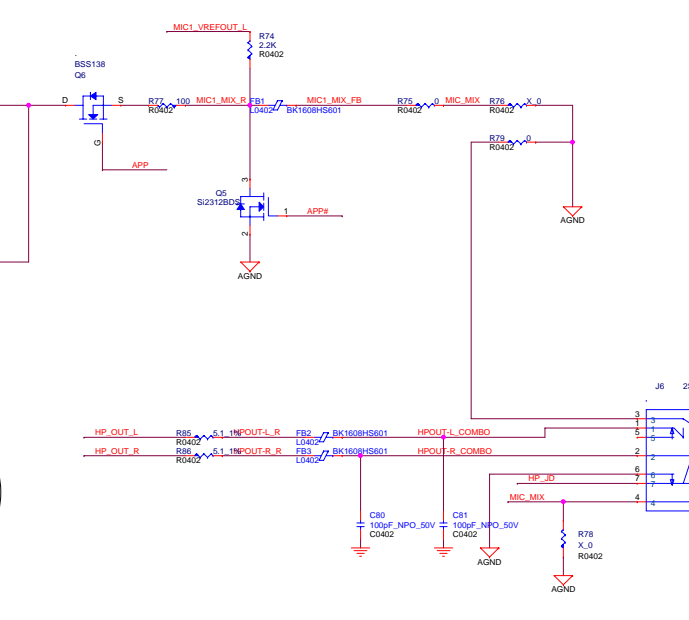
Use 250mils wide trace bridging AGND and DGND at codec.
See design guide.

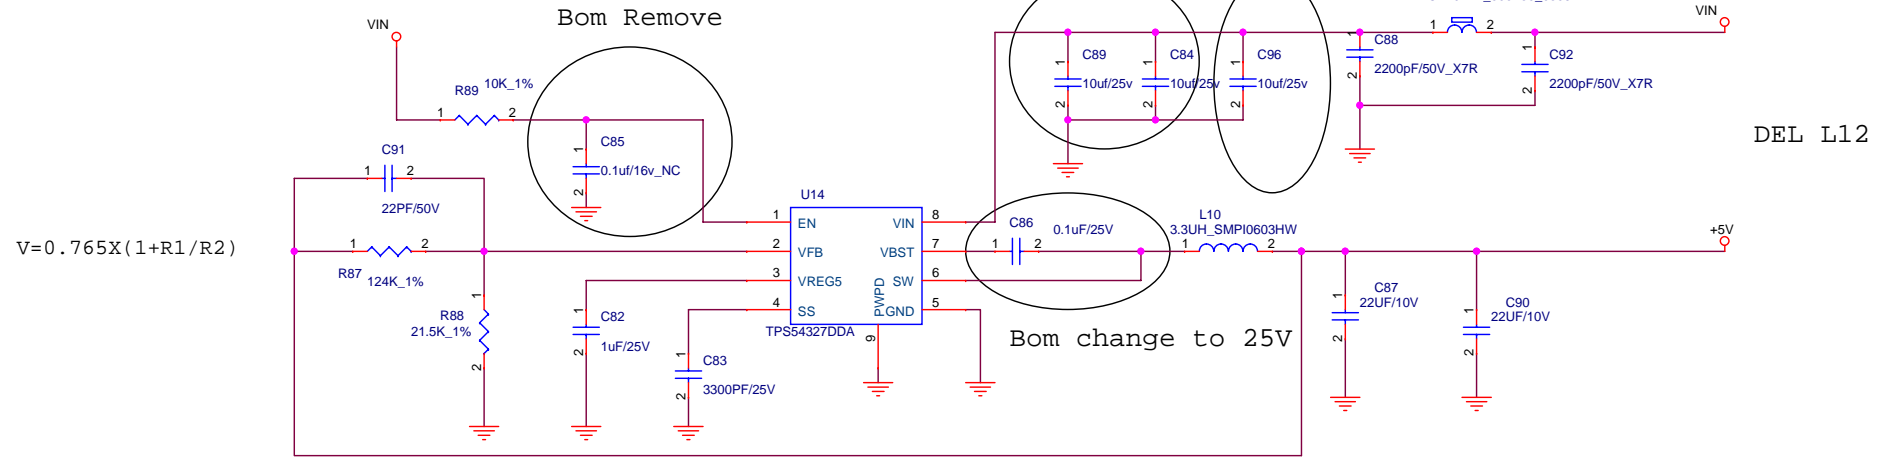
Change Package to 1206 and add 10UF/25V
